Lotus Elan M100 Service Bulletins
Series 1 and Series 2 1990 - 1996

SERVICE BULLETIN

Number 1990/11

TITLE: Replacement of headlamp flap 'J' links.

Fettling of Right Hand Pod Lower Edge

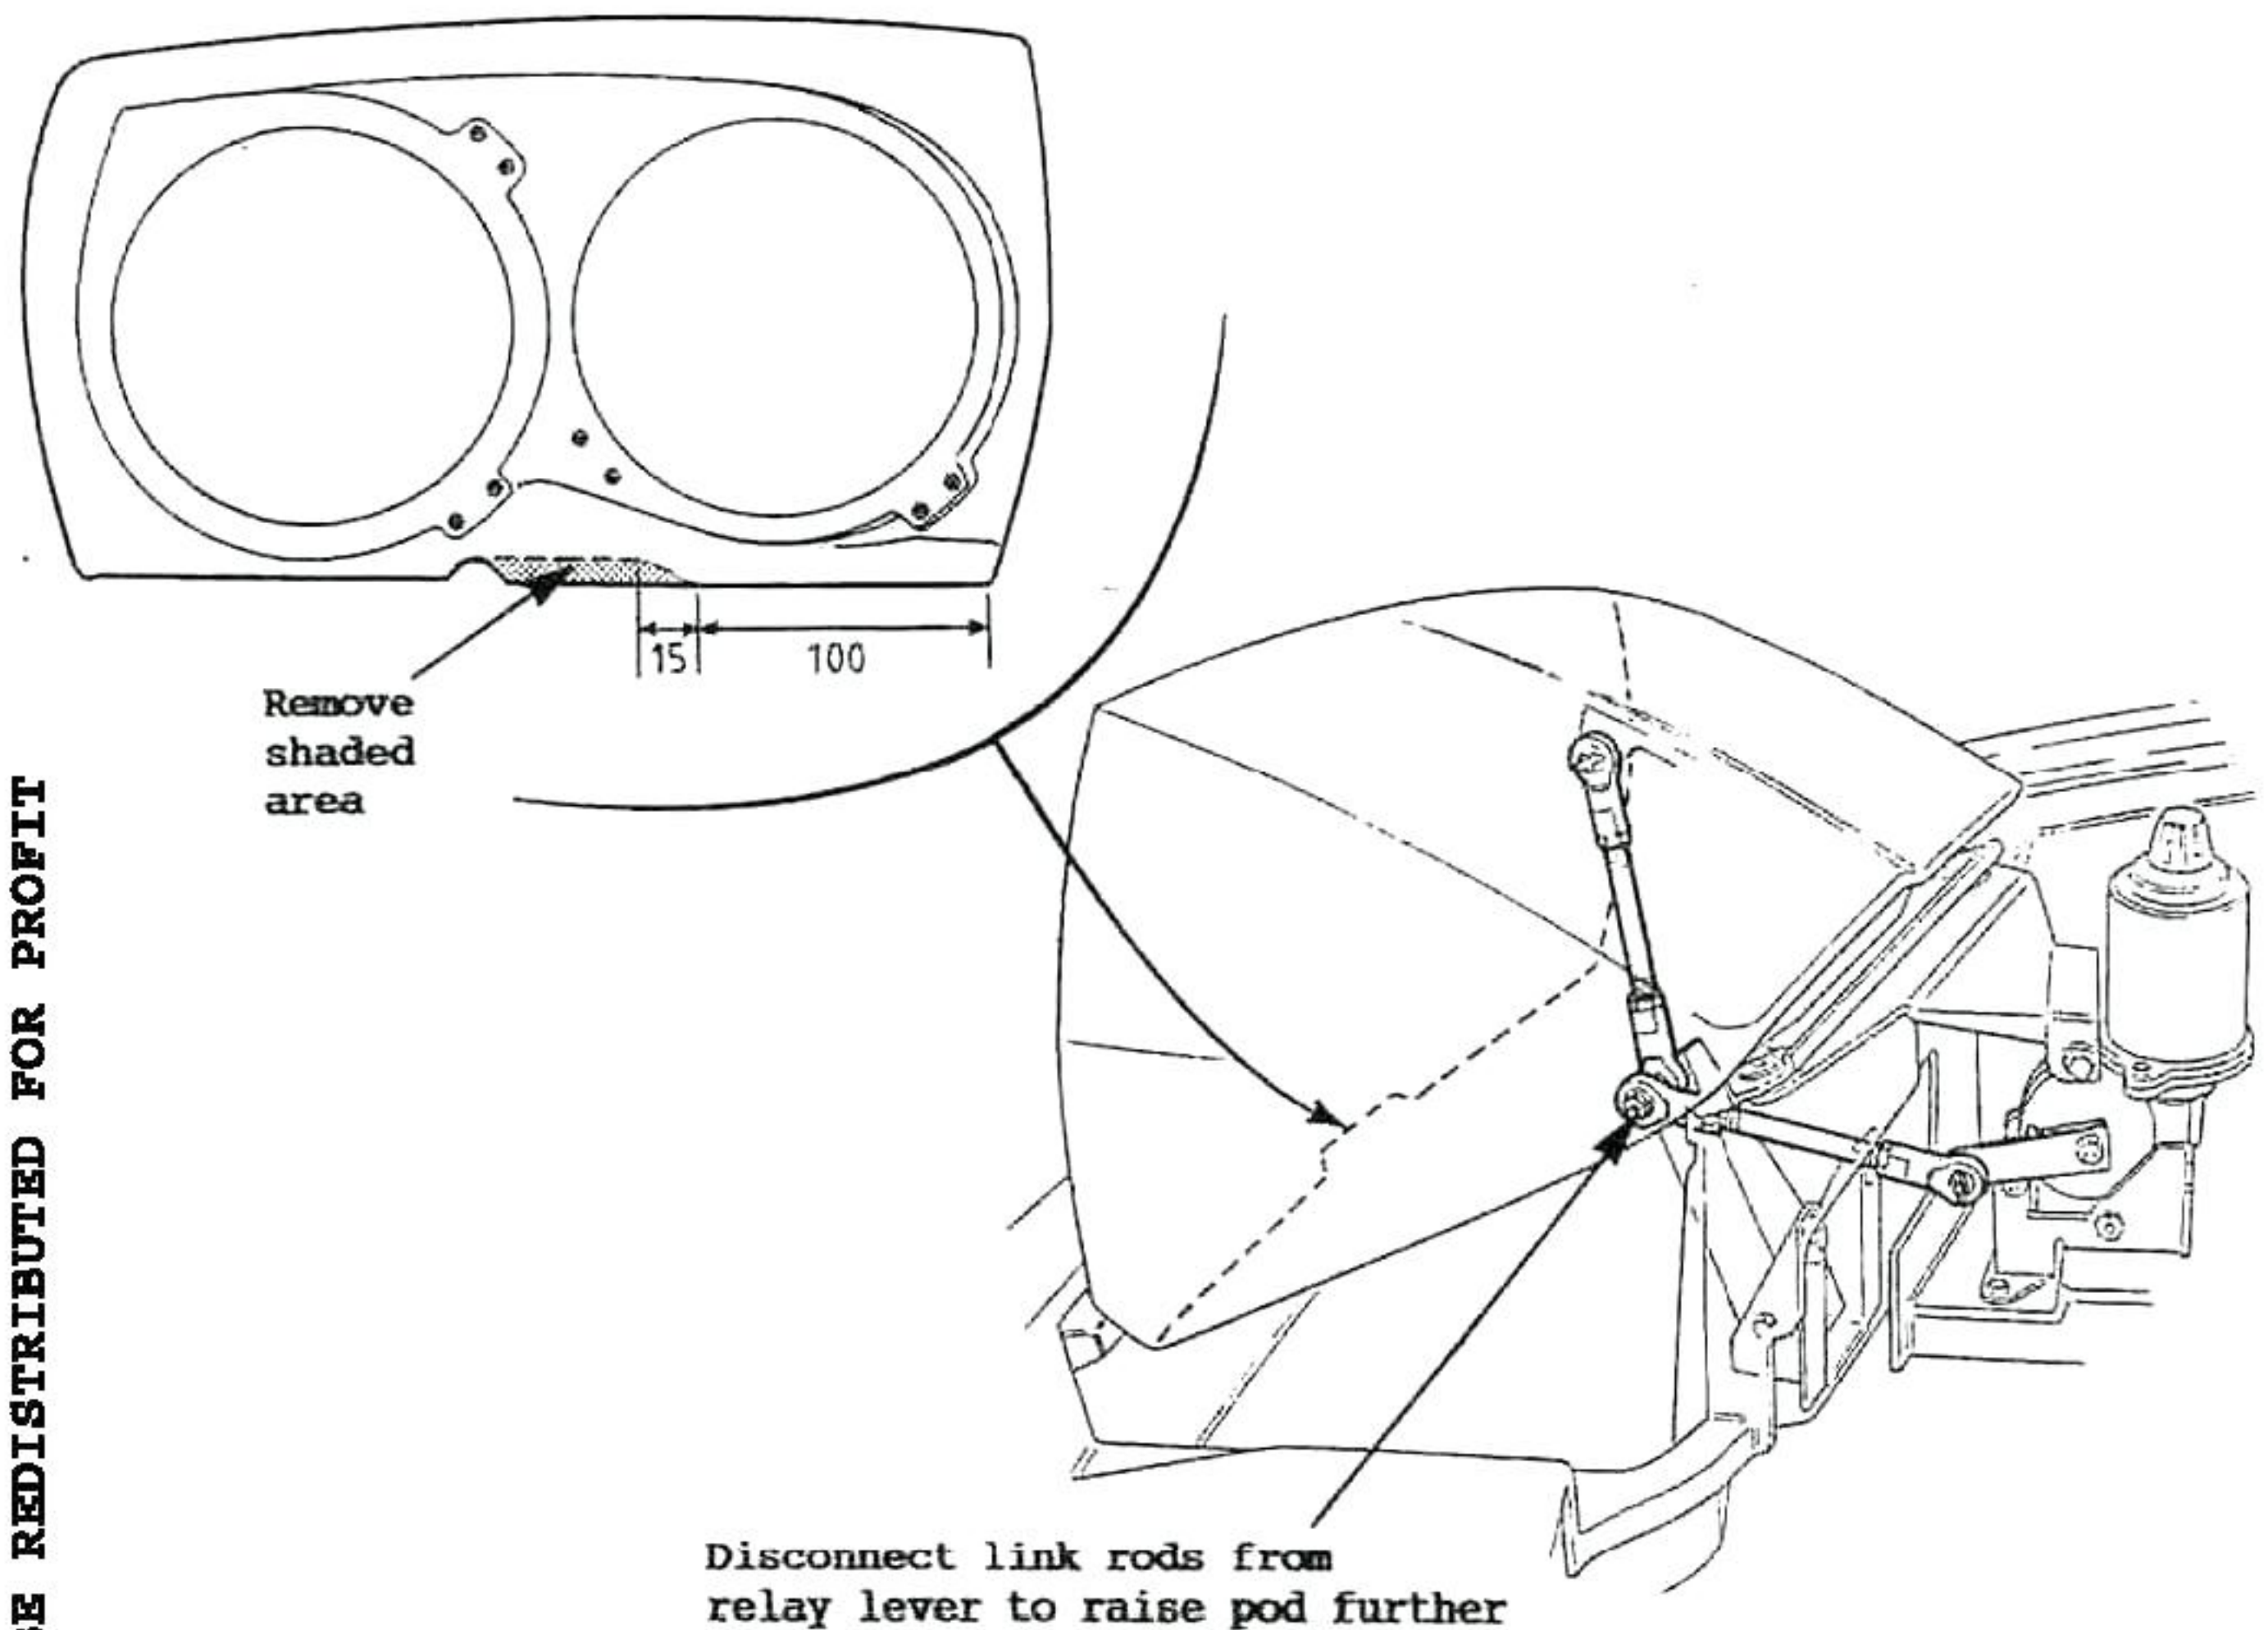
ACTION: At the next opportunity (i.e. next time the vehicle is on the dealer premises), all cars with the new headlamp system in the following VIN range, should have the fettling of the right hand pod checked/modified as detailed on pages 3/4.

If necessary, the pod link rod should be disconnected from the relay lever to permit the pod to be raised further for improved access, and the lower edge marked out and fettled using a router or similar tool, until the profile matches that of the template. This will provide increased clearance of the pod edge (with pod lowered) to the low pressure power steering hose at the rear of the pod well. Inspect this hose for any signs of chafing, and replace if necessary.

New horn bracket
B100B0948F

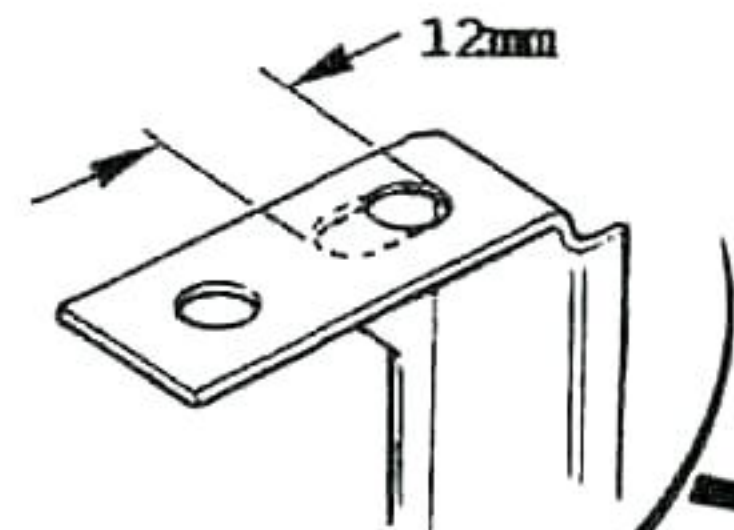
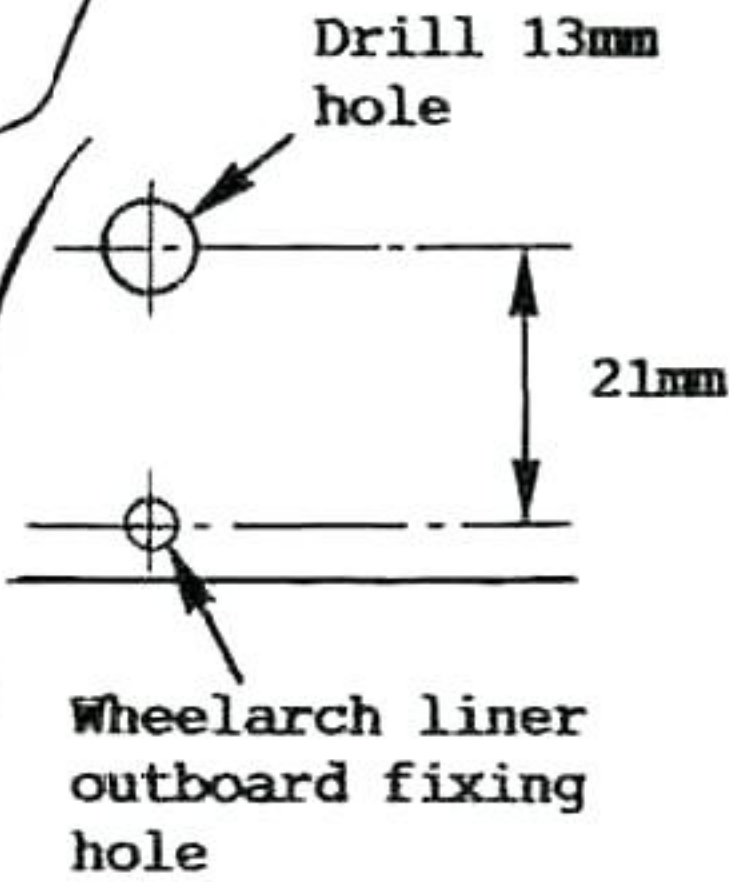
ACTION: At the next opportunity (i.e. next time the car is on the dealer premises), on all '90 model year cars prior to VIN L 6333 (refer to S/B 1990/31), replace the two existing horn brackets with the new one-piece design.

Elongate front
hole towards rear

Horn outlet
bell pointing
downwards

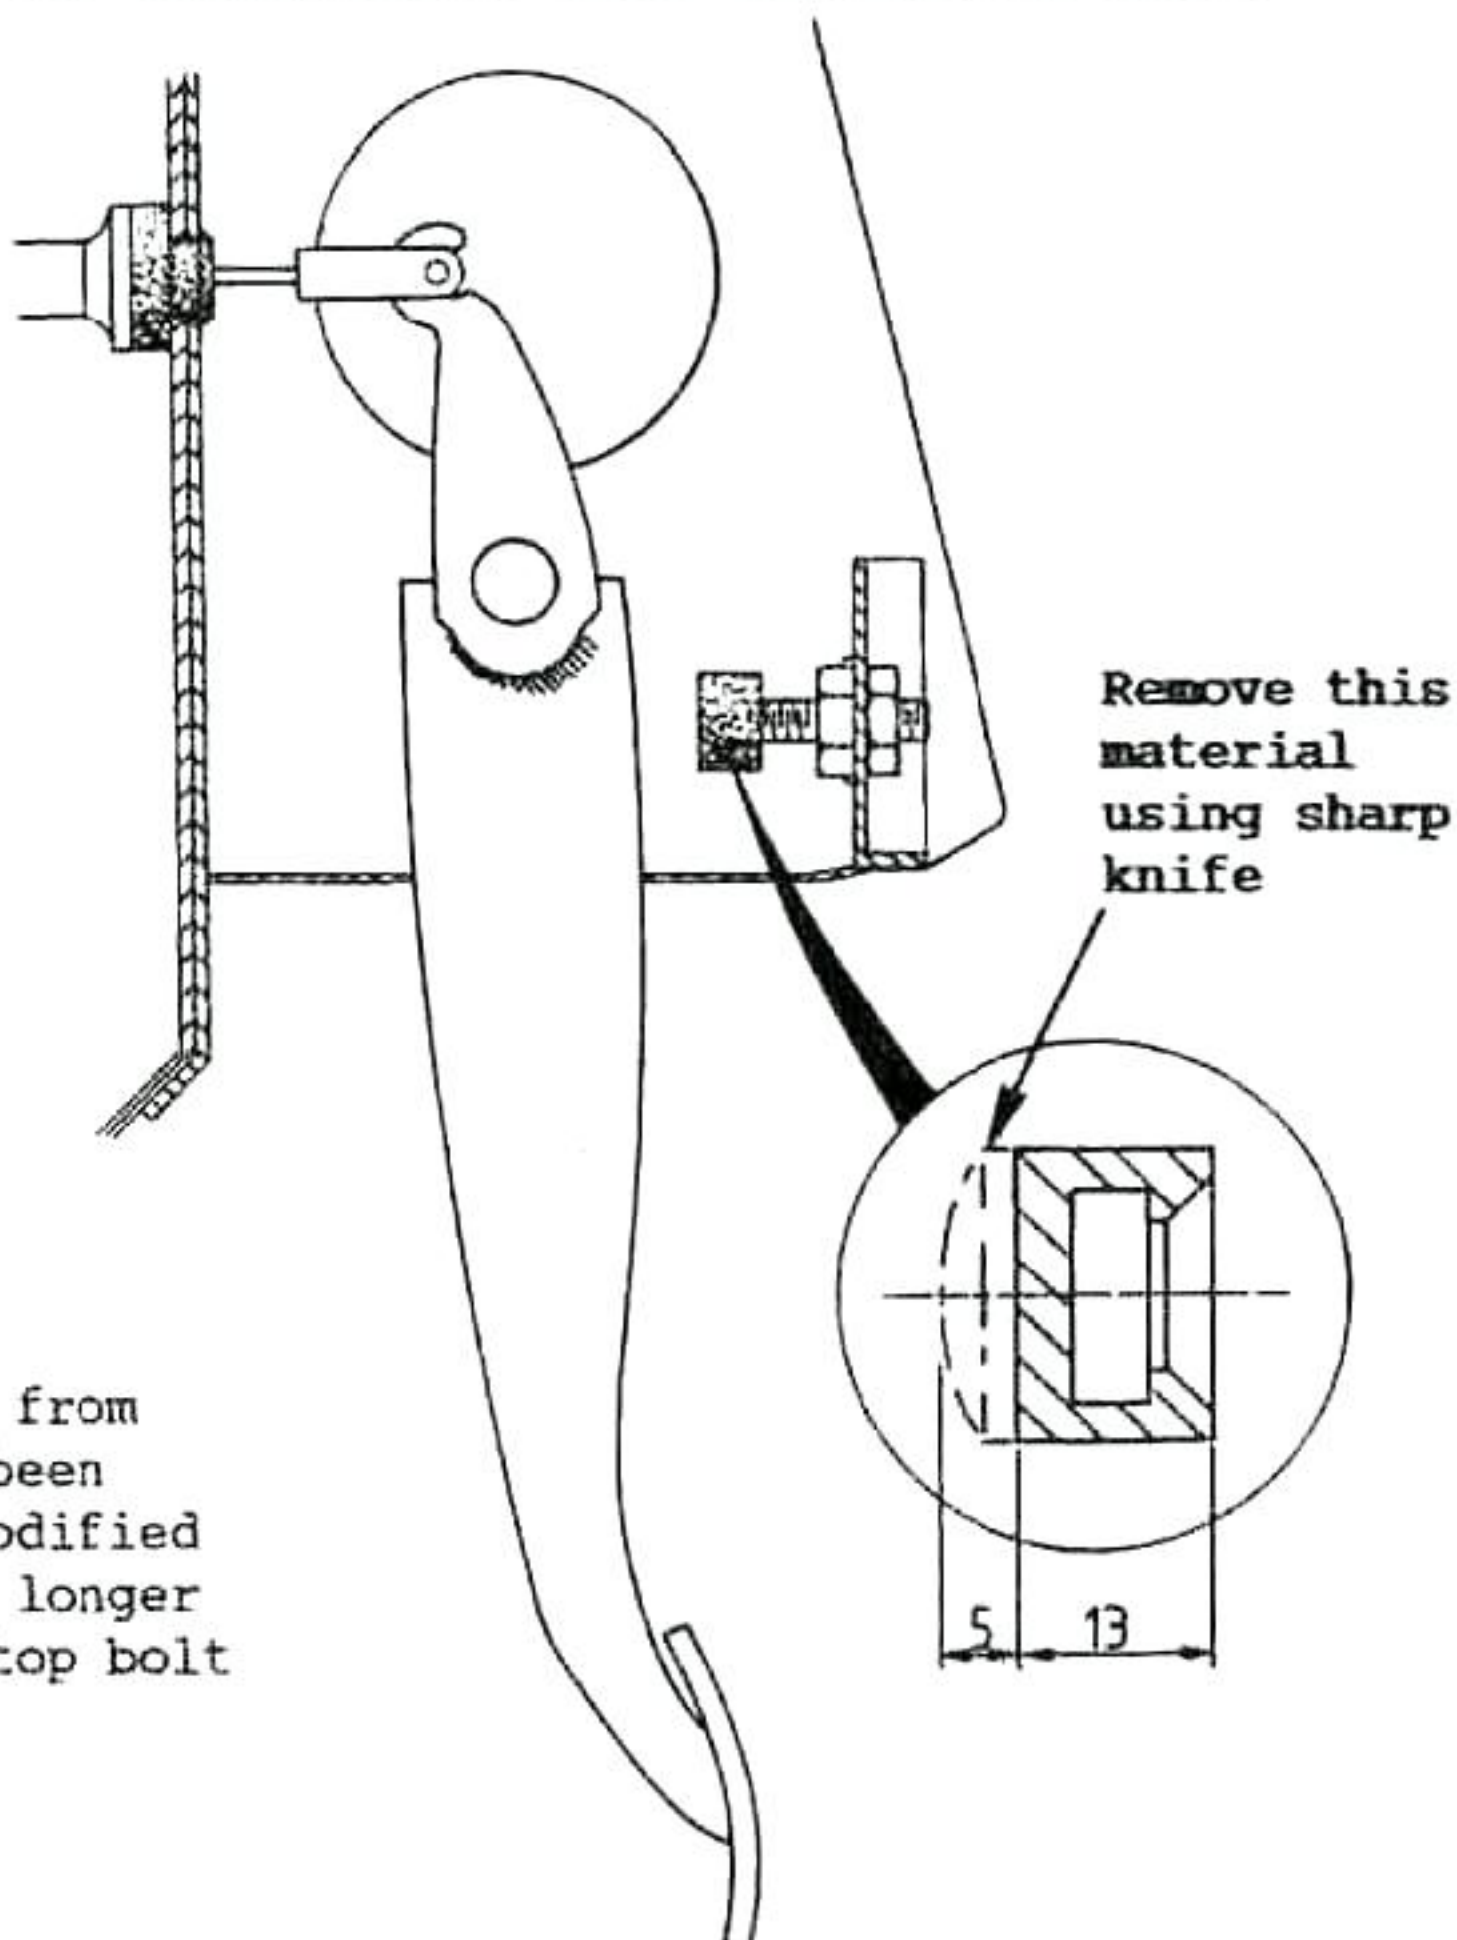
TITLE: Modification of clutch pedal upstop buffer.

REASON: The modified clutch pedal upstop buffer, with reduced compliance, minimises the possibility of the clutch cable becoming inadvertently unhooked from the pedal, especially after rapid pedal release.

ACTION: If the clutch pedal area is receiving attention, or if a cable disconnection has been experienced, it is recommended to modify the pedal upstop buffer in accordance with the diagram below. The correct sequence of clutch and brake pedal adjustment is as follows:

- Adjust the brake pedal pushrod to achieve a small amount of free play at the pedal.
- Adjust the brake light switch to operate the brake lights after approx. 10 mm of pedal pad travel.
- Adjust the clutch pedal upstop (with modified buffer fitted) to set pedal height equal to brake pedal.
- Adjust clutch cable at transmission end to achieve 3 to 6 mm clearance between the transmission lever arm and the cable plastic trunnion.

All '92 M.Y. cars from
VIN N 6276 have been
fitted with the modified
buffer and a 5 mm longer
(35 vs 30 mm) upstop bolt
A075W1041Z.

Relay stations viewed from beneath

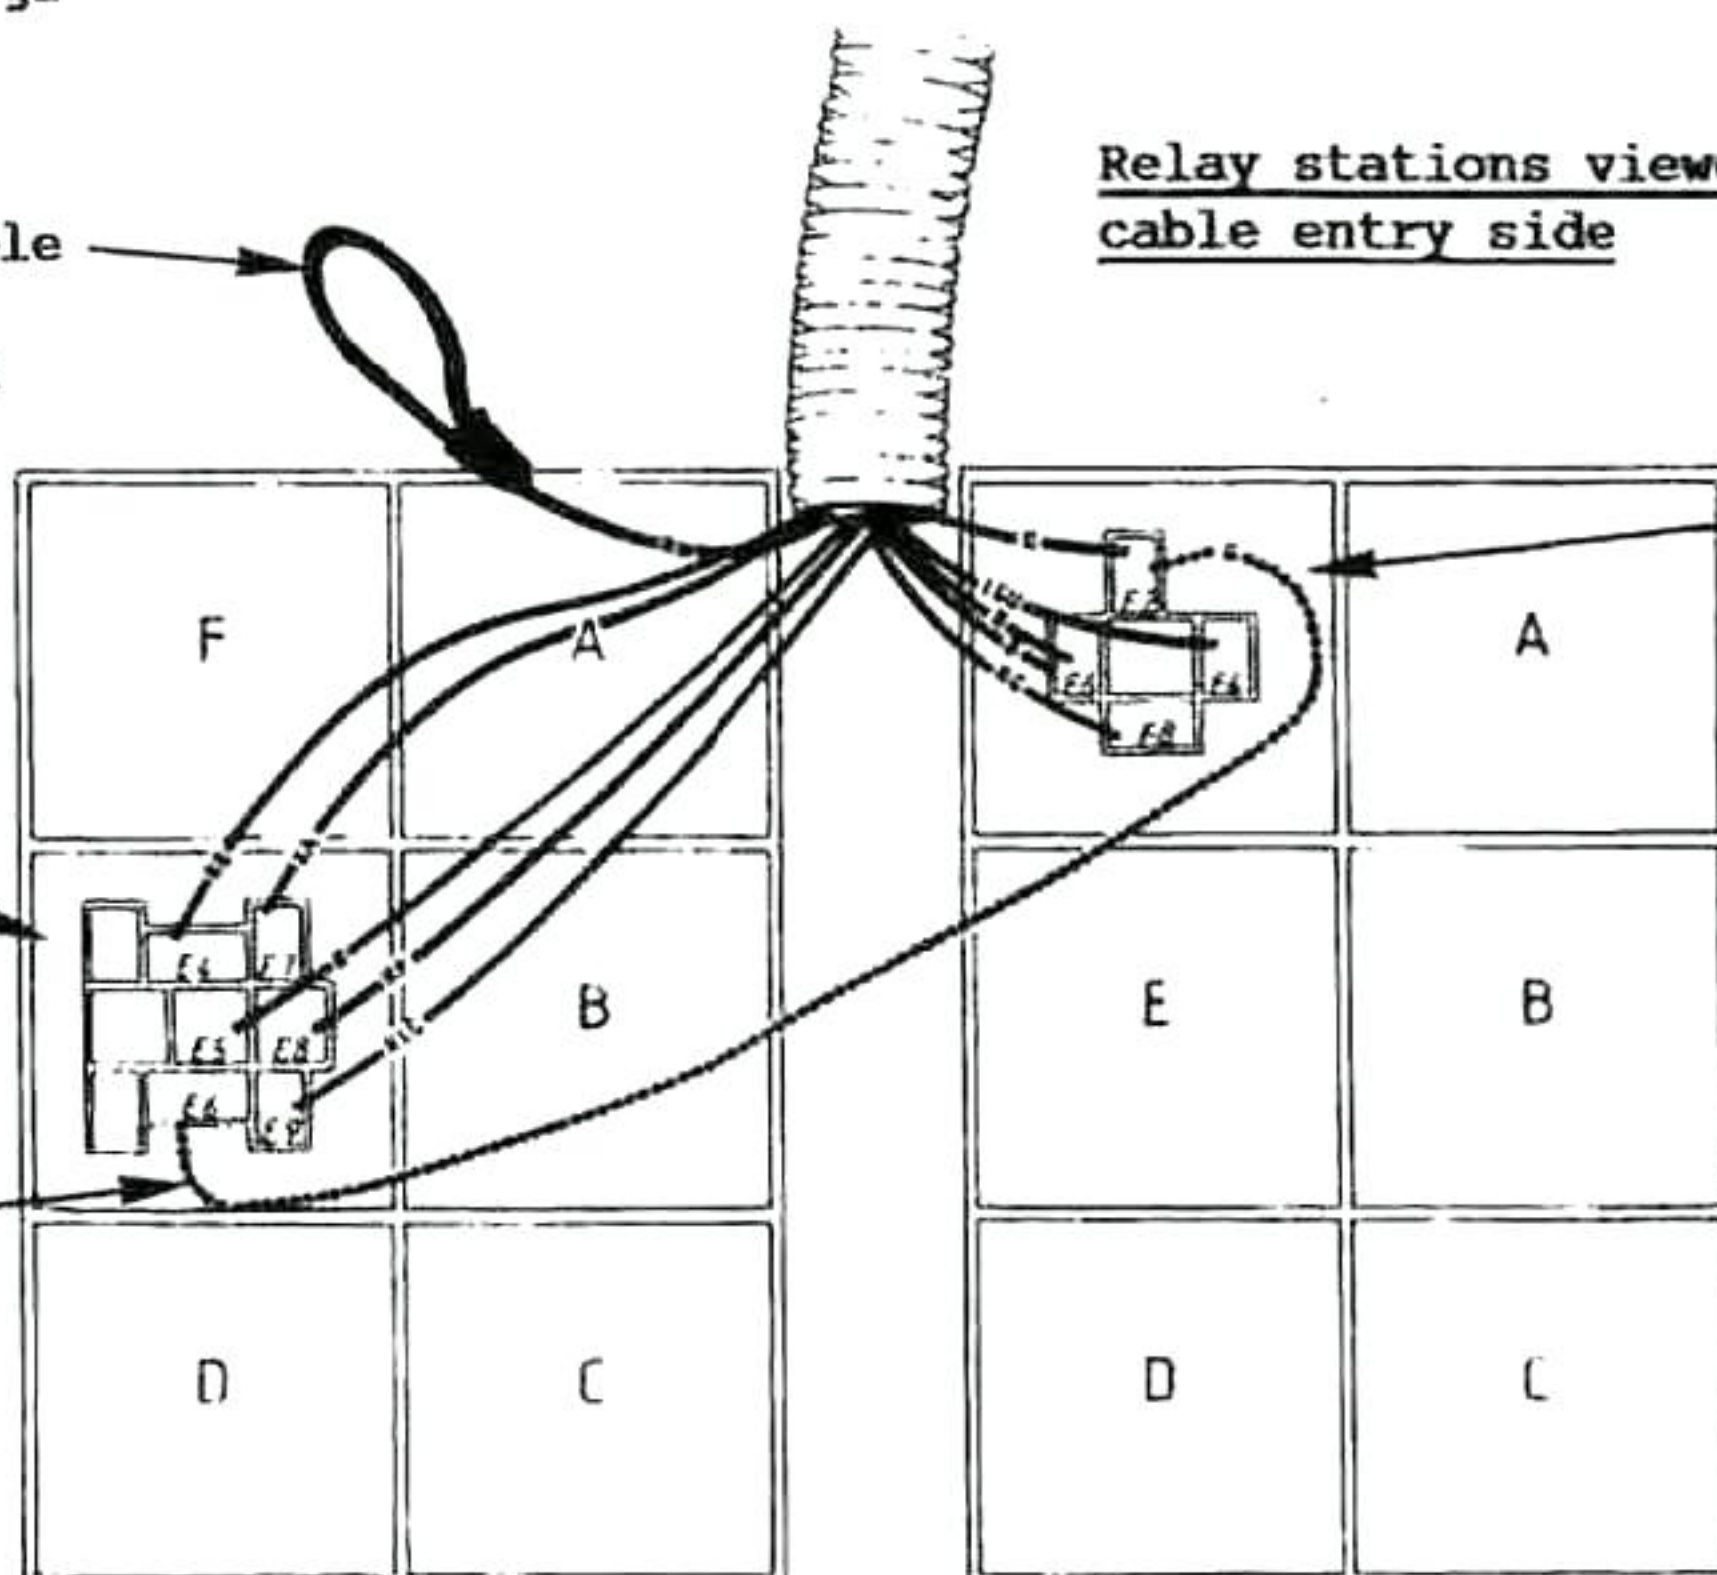
3. Use a jewellers screwdriver or similar to remove the red/white cable from cavity E6 of the rheostat module base. Insulate and tape back.
4. Remove the green cable from cavity F2 of the heated mirror timer module base and cut off the terminal. Add 250mm of 0.5mm² green cable, and terminate the pair of cables with the longer legged spade terminal supplied in the kit. Refit the terminal into cavity F2 of the timer module base.

Red/white cable removed from cavity E6 and taped back
